ADDENDUM NO. 4

TO: PLANS AND SPECIFICATIONS FOR STATE OF MISSOURI

Renovate Mechanical / Electrical / Life-Safety / State Office Building
Jefferson State Office Building
205 Jefferson Street
Jefferson City, MO 65101
PROJECT NO. O1911-01

M4.1

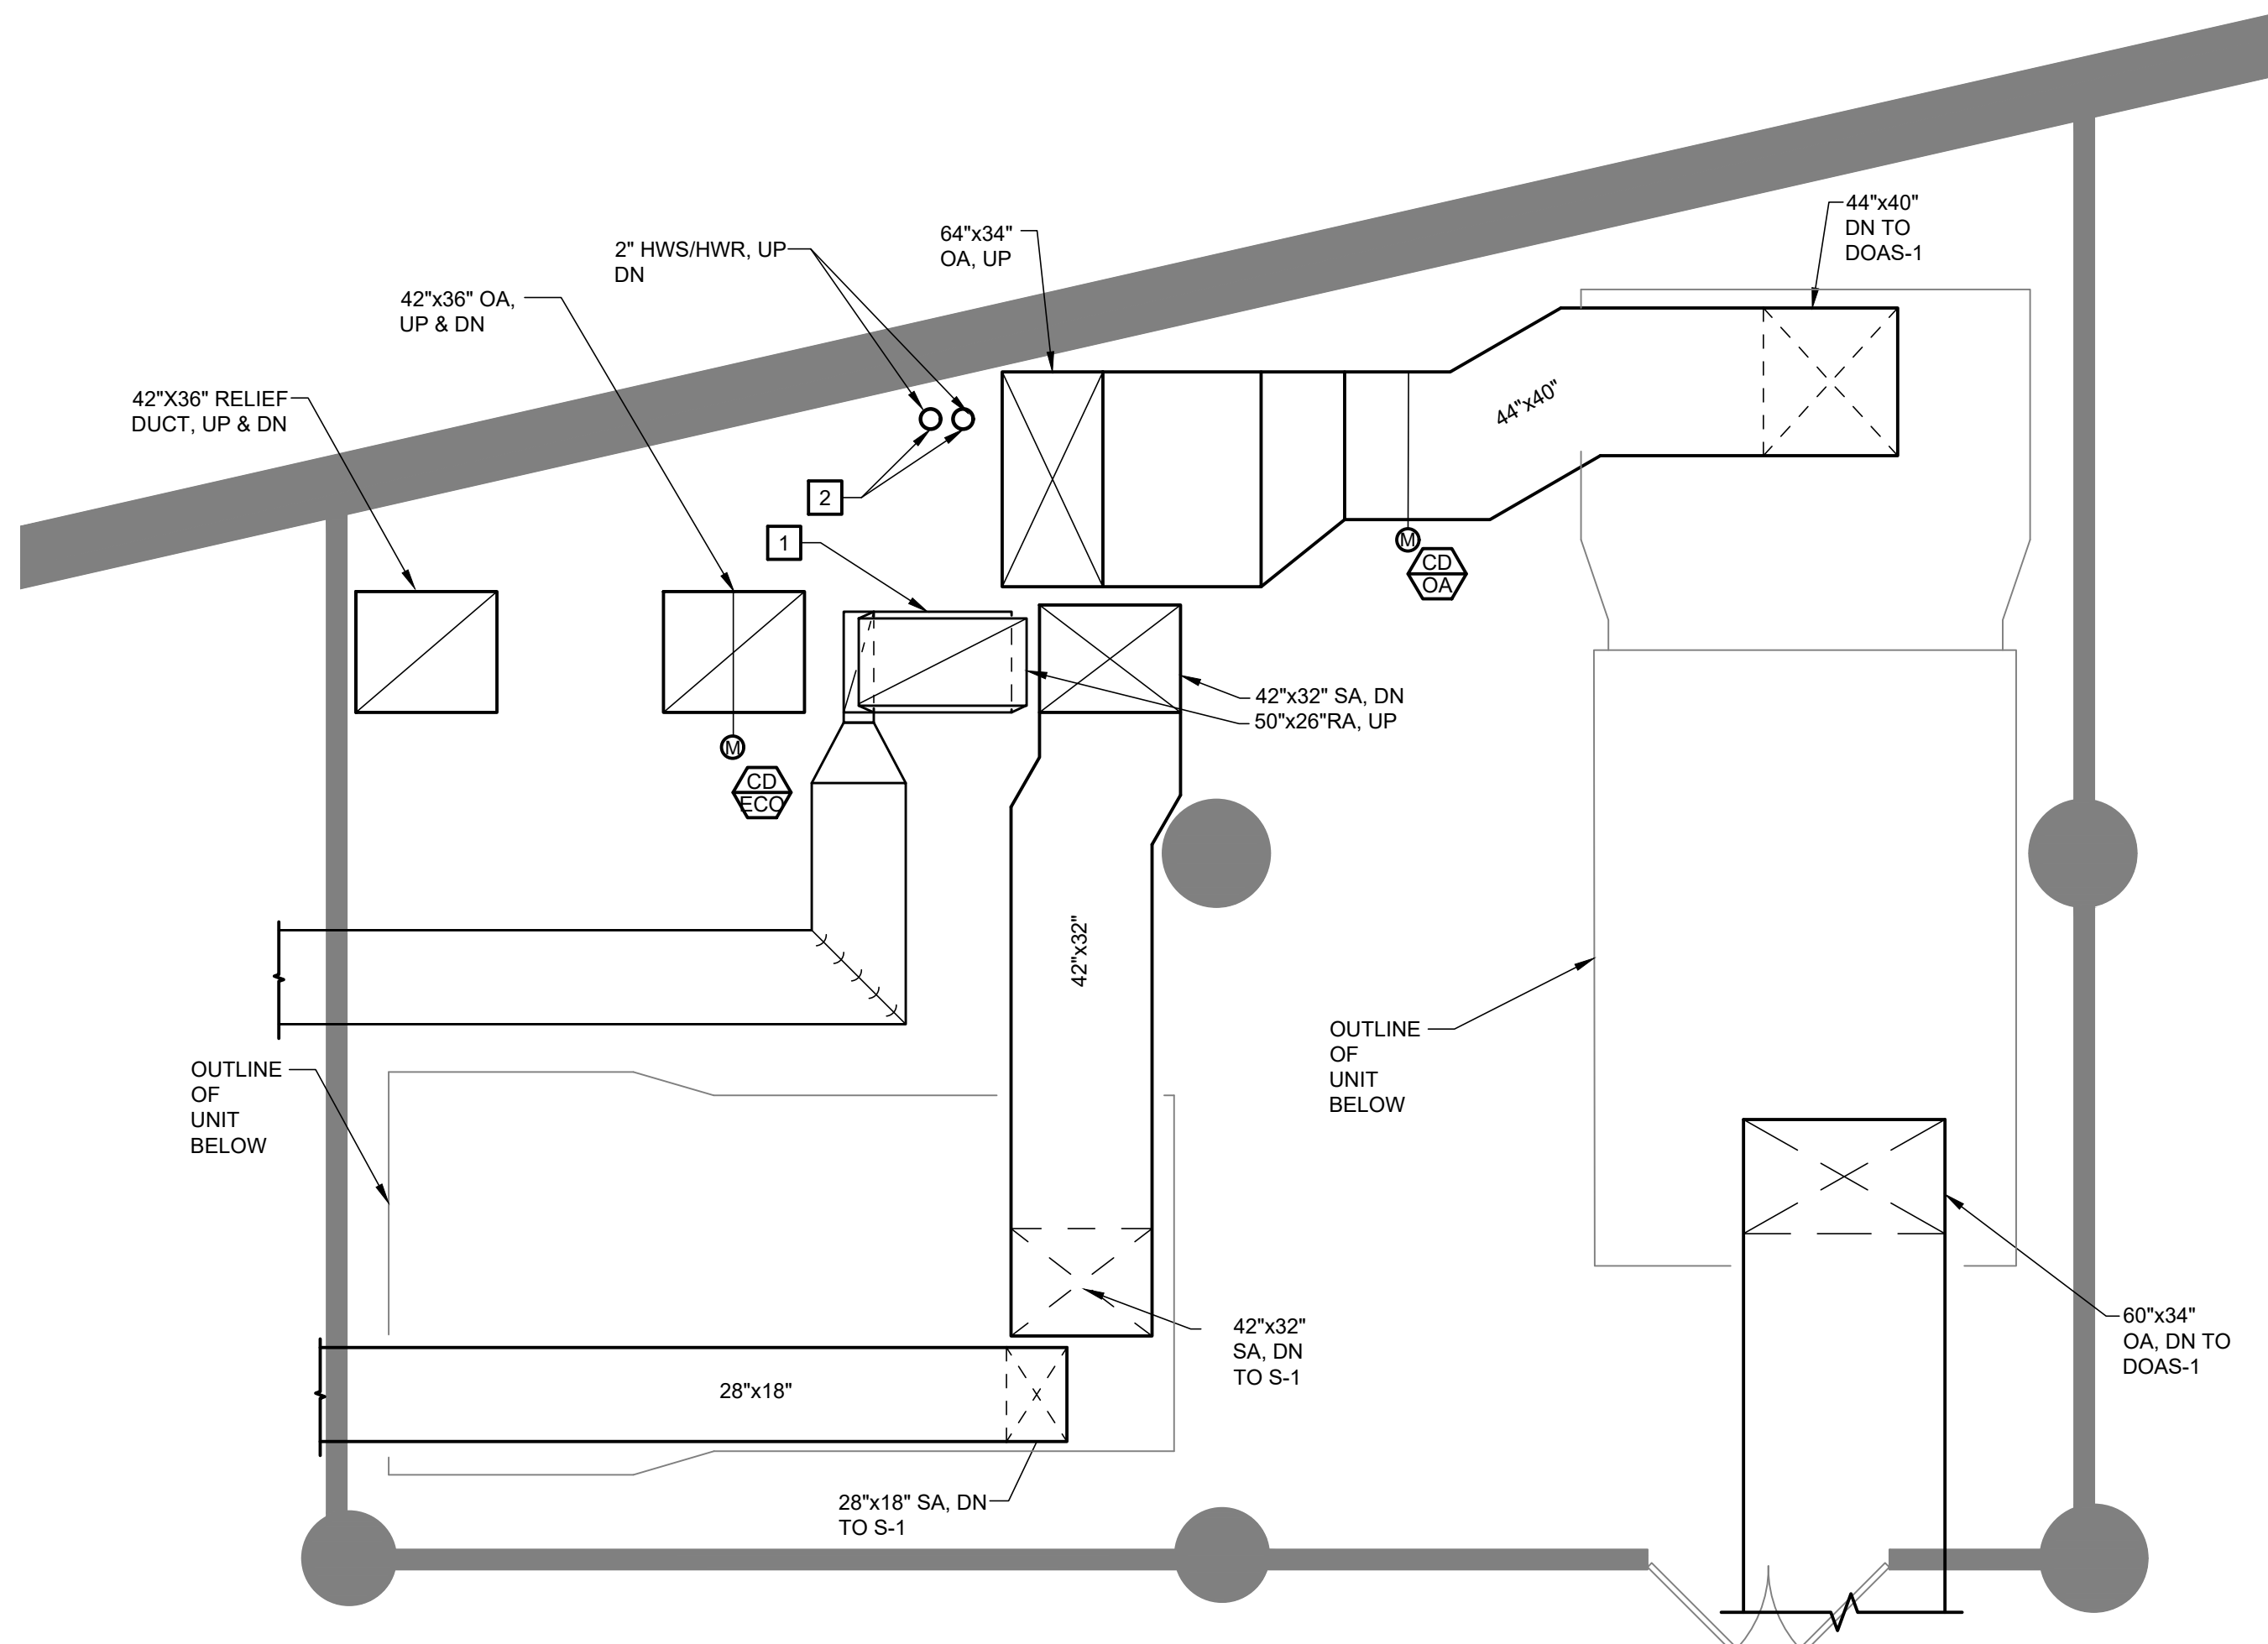
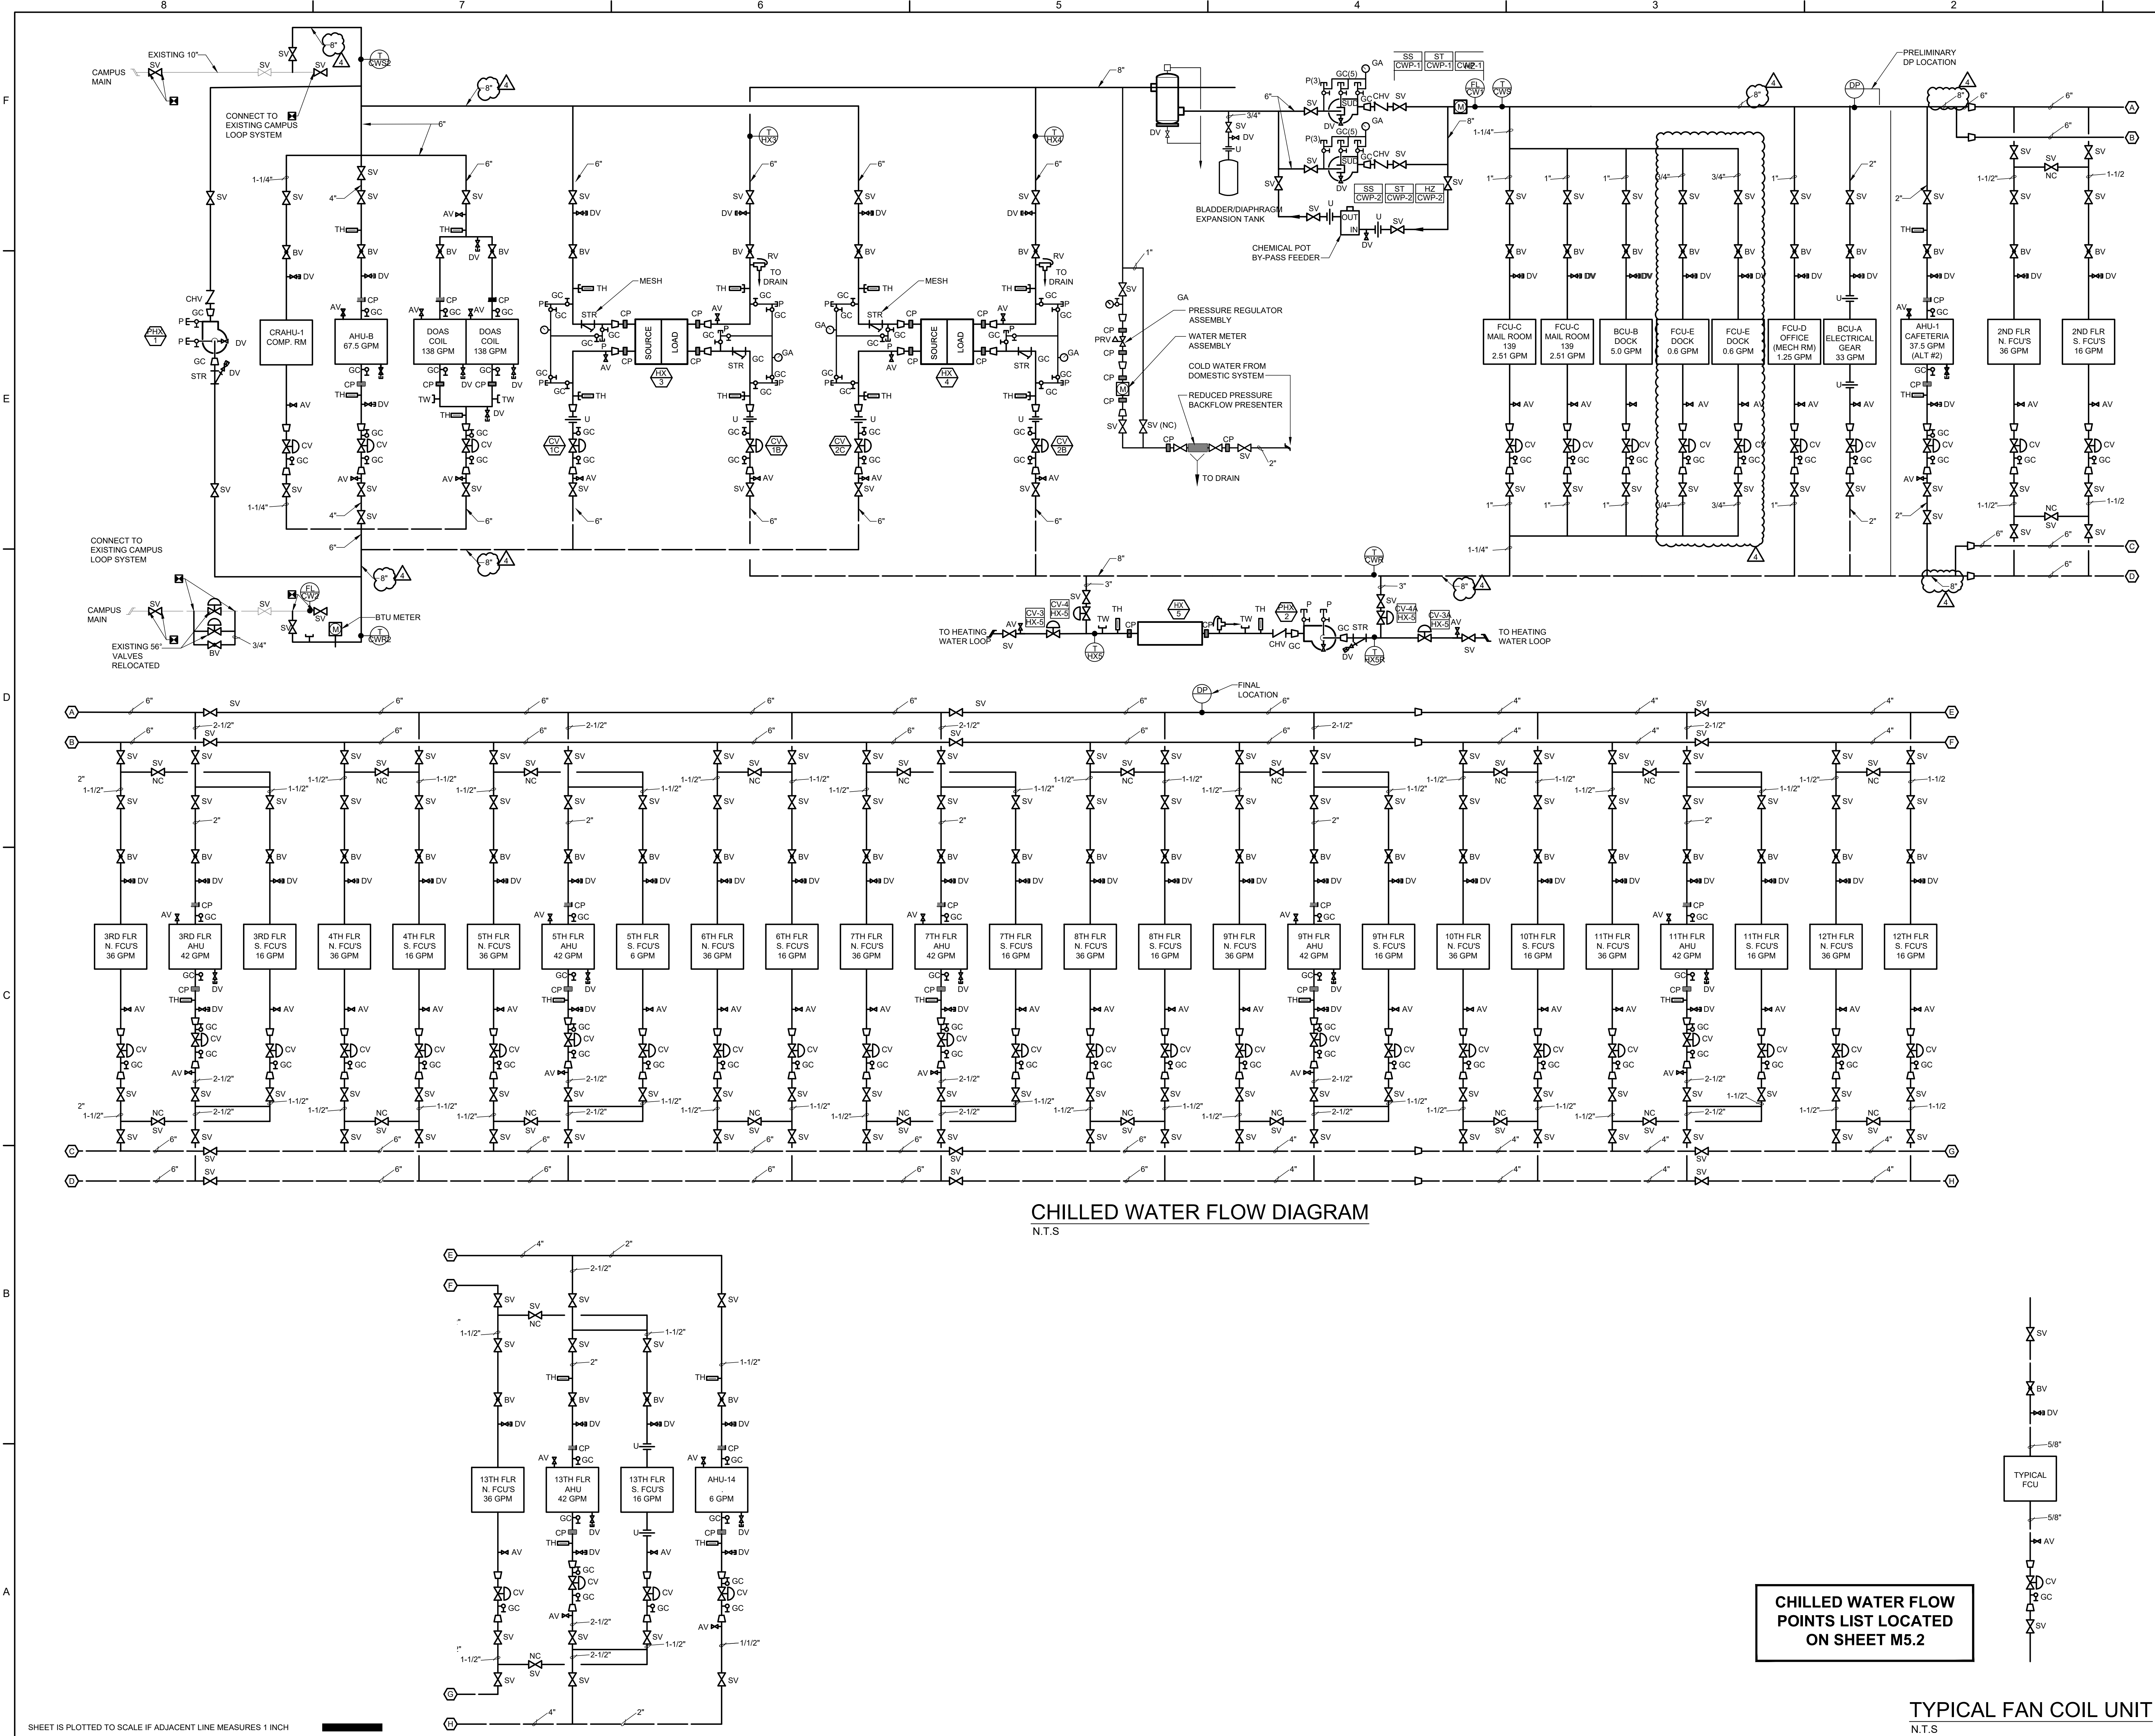
- a. **ADJUSTED** – Heat exchanger connection points.
 - b. **ADJUSTED** – Pipe Size.
 - c. **ADDED** – Housekeeping pads.
 14. Drawing M4.1:
 - a. **ADJUSTED** – Pump Tags.

SHEET NUMBER:
M6.4
127 OF 244 SHEETS

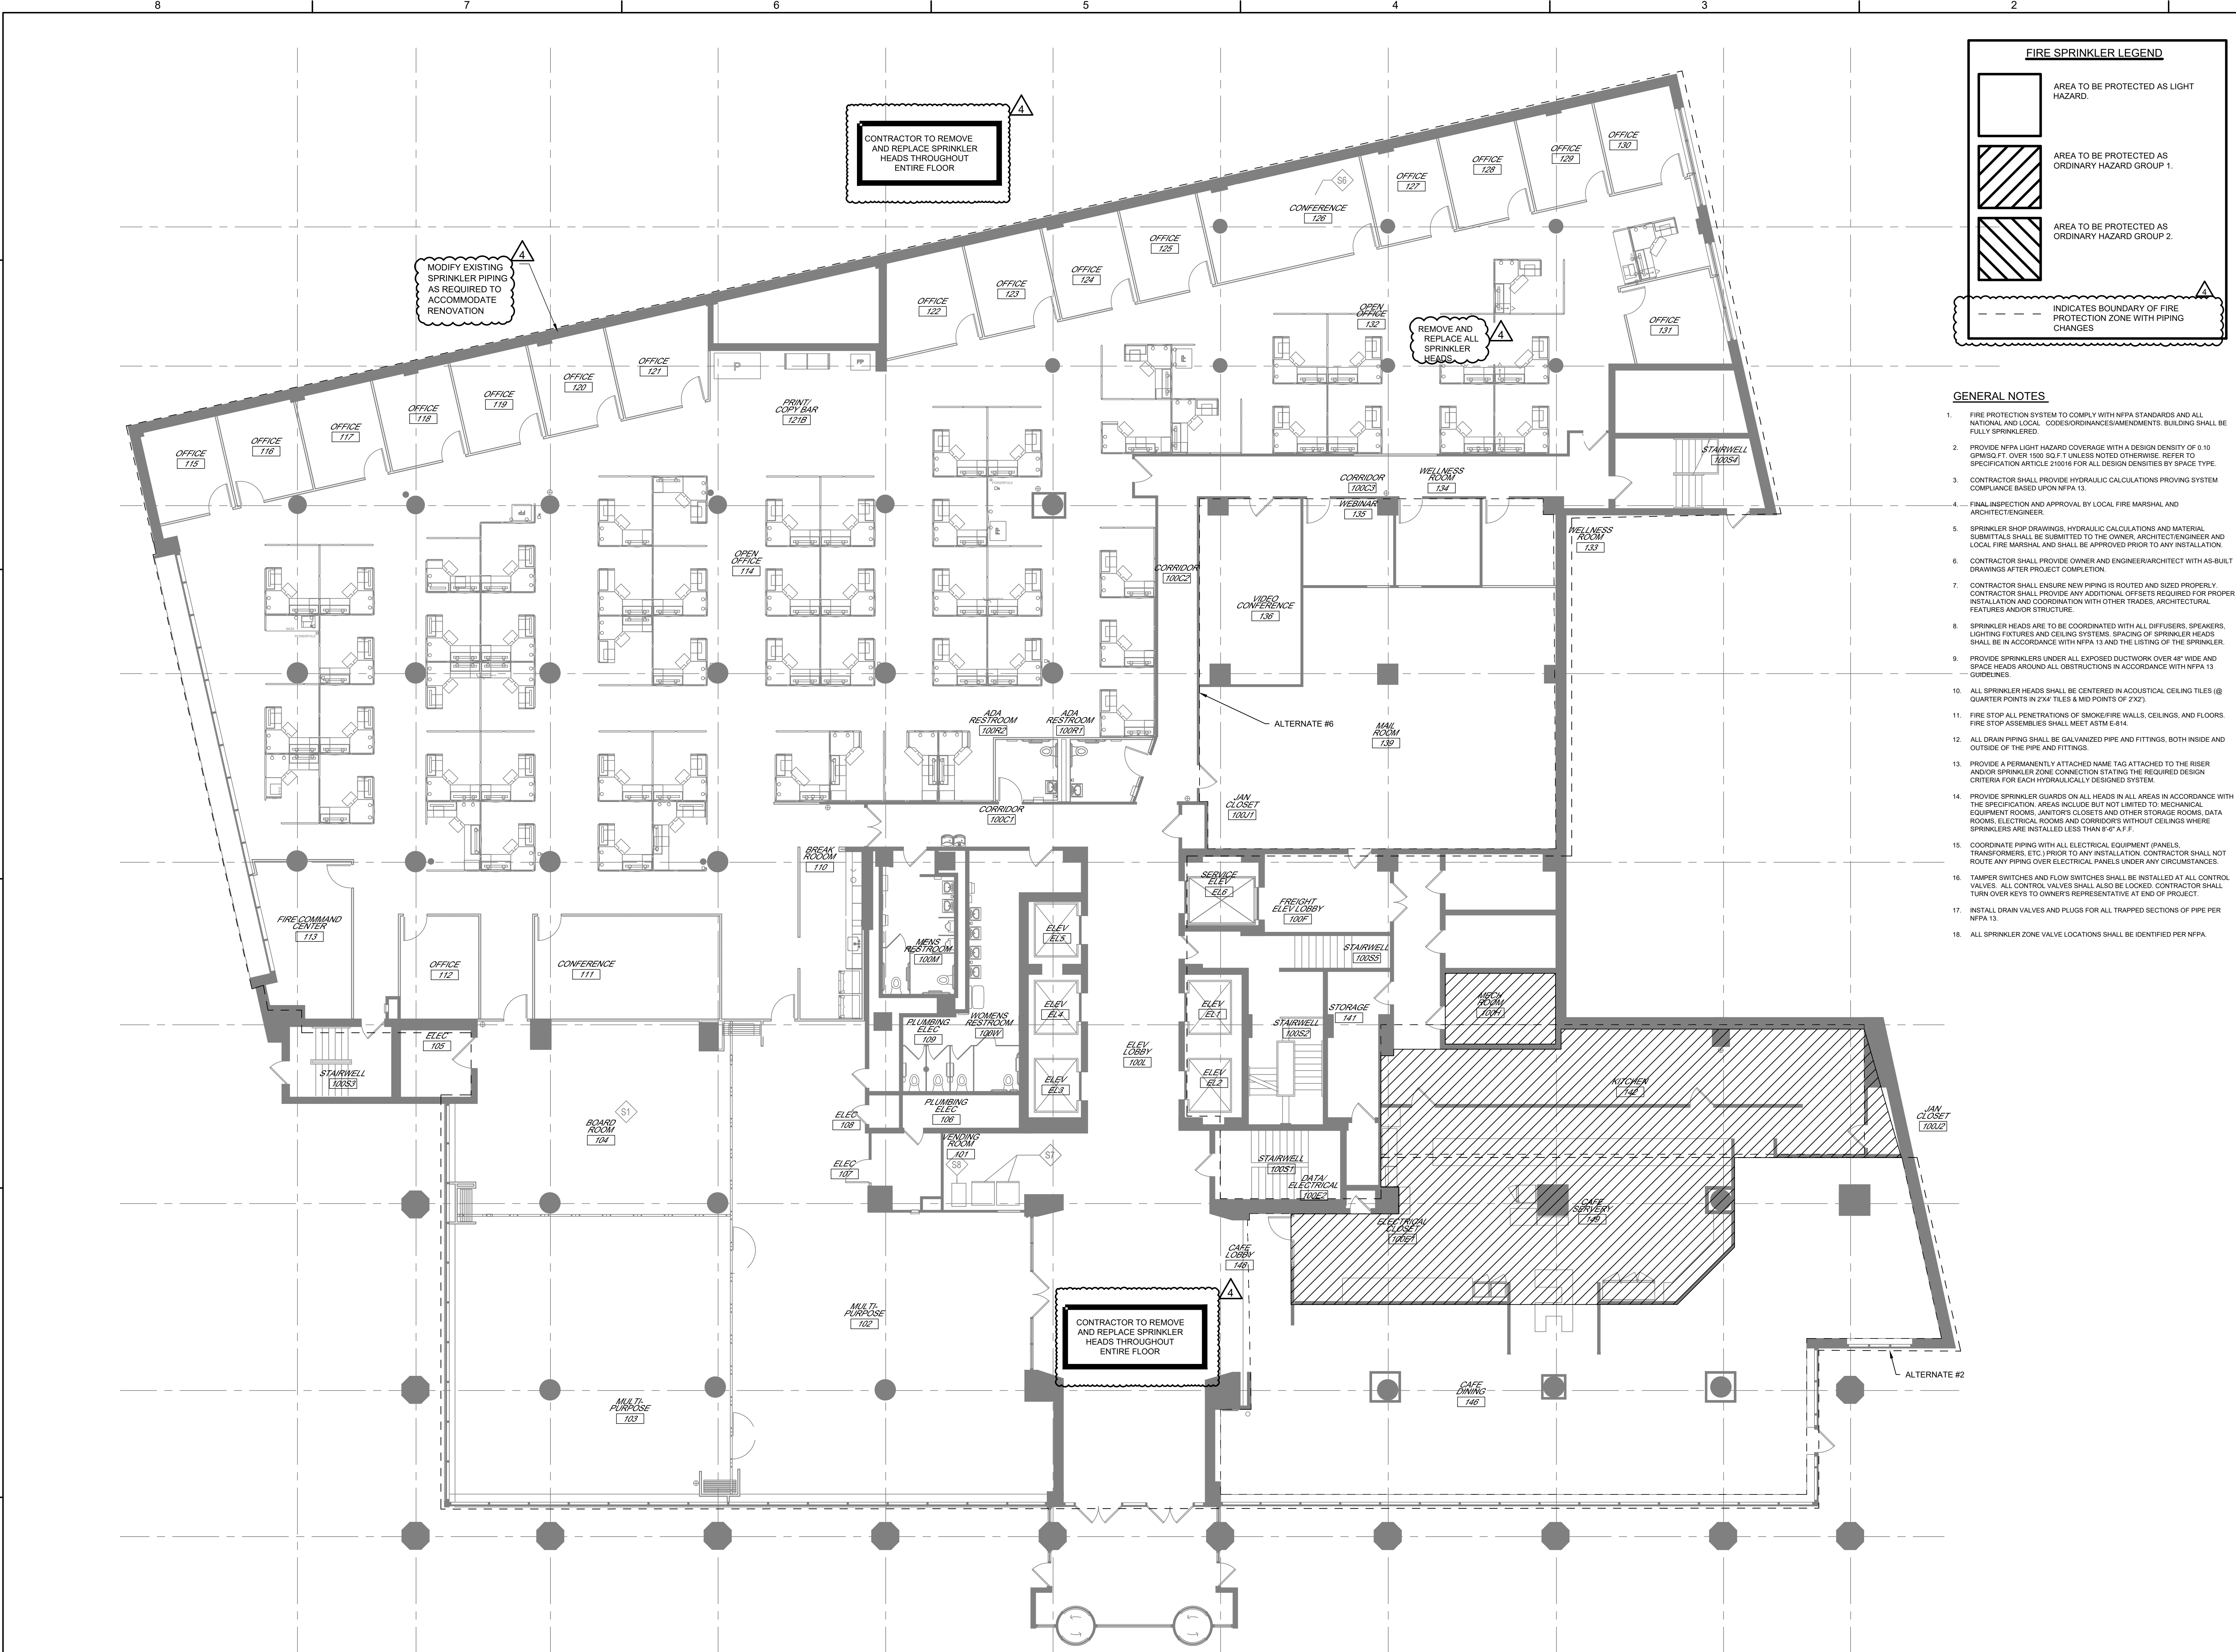
18. Drawing M6.4:
 - a. **ADDED** – DX Coil Schedule.
 1. Drawings: FP3.1, FP3.2, FP3.3, FP3.4, FP3.5, FP 3.6, FP3.7, FP3.8, FP3.9, FP3.10, FP3.11, FP3.12, FP3.13

Response: Plans updated to include piping to FCU-E.
- g. Can you provide a schedule for the dx coil located in the penthouse?
Response: Schedule has been added to sheet M6.4
